UNITED STATES PATENT AND TRADEMARK OFFICE

APPLICATION NO.	FILING DATE	FIRST NAMED INVENTOR	ATTORNEY DOCKET NO.	CONFIRMATION NO.
10/671,440	09/29/2003	Yoshitaka Sasaki	117329	6666

Office Action Summary	Application No. 10/671,440	Applicant(s) SASAKI ET AL	
	Examiner Julie Anne Watko	Art Unit 2653

DETAILED ACTION***Drawings***

**Fig. 4 labeled in IFW as having been filed
September 29, 2003****Fig. 5 labeled in IFW as having been filed
September 29, 2003**

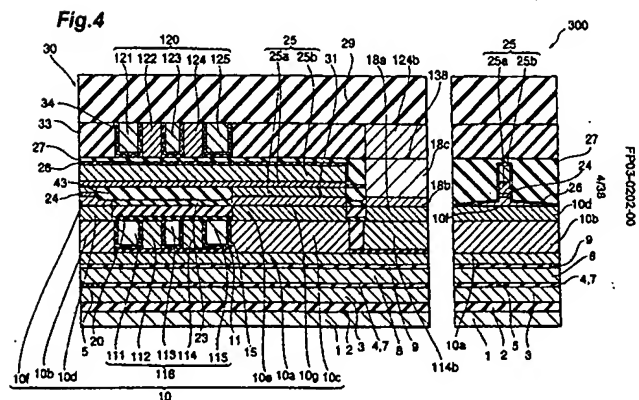
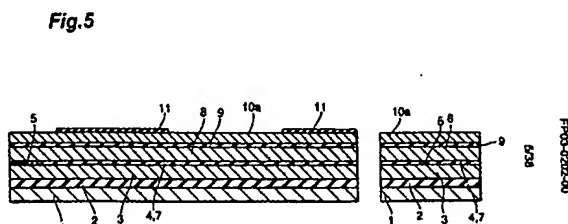
1. The drawings were received on December 22, 2005. These drawings are disapproved. Figs. 4A-B and 5A-B are not separately labeled. The following is a quotation from 37 CFR § 1.84(u)(1): "Partial views intended to form one complete view, on one or several sheets, must be identified by the same number followed by a capital letter." The replacement drawings filed December 22, 2005, are labeled Fig. 4 and Fig. 5, NOT Fig. 4A, Fig. 4B, Fig. 5A and Fig. 5B. The replacement drawings have NOT been entered.

2. The original drawings, filed on September 29, 2003, are objected to for the reasons stated in the office action mailed August 25, 2005. On page 13, 1st paragraph, Applicant states that "As clearly shown in the drawings filed on September 29, 2003, the figures are properly labeled Fig. 4A and Fig. 4B. Similarly, Fig. 5 is properly labeled as Fig. 5A and Fig. 5B." The Examiner has considered this argument thoroughly and asserts that in the drawings labeled in IFW as having been filed on September 29, 2003, the figures are improperly labeled Fig. 4 and Fig. 5.

Although Applicant attempted to replace the drawings twice, neither attempt was complete. The September 29, 2003 drawings remain pending in the application. The September 29, 2003, drawings are objected to as failing to comply with 37 CFR § 1.84(u)(1).

Separate figures are not separately labeled (see Figs. 4 and 5, for example).

Corrected drawing sheets in compliance with 37 CFR 1.121(d) are required in reply to the Office action to avoid abandonment of the application. Any amended replacement drawing sheet should include all of the figures appearing on the immediate prior version of the sheet, even if only one figure is being amended. Each drawing sheet submitted after the filing date of an application must be labeled in the top margin as either "Replacement Sheet" or "New Sheet" pursuant to 37 CFR 1.121(d). If the changes are not accepted by the examiner, the applicant will be notified and informed of any required corrective action in the next Office action. The objection to the drawings will not be held in abeyance.
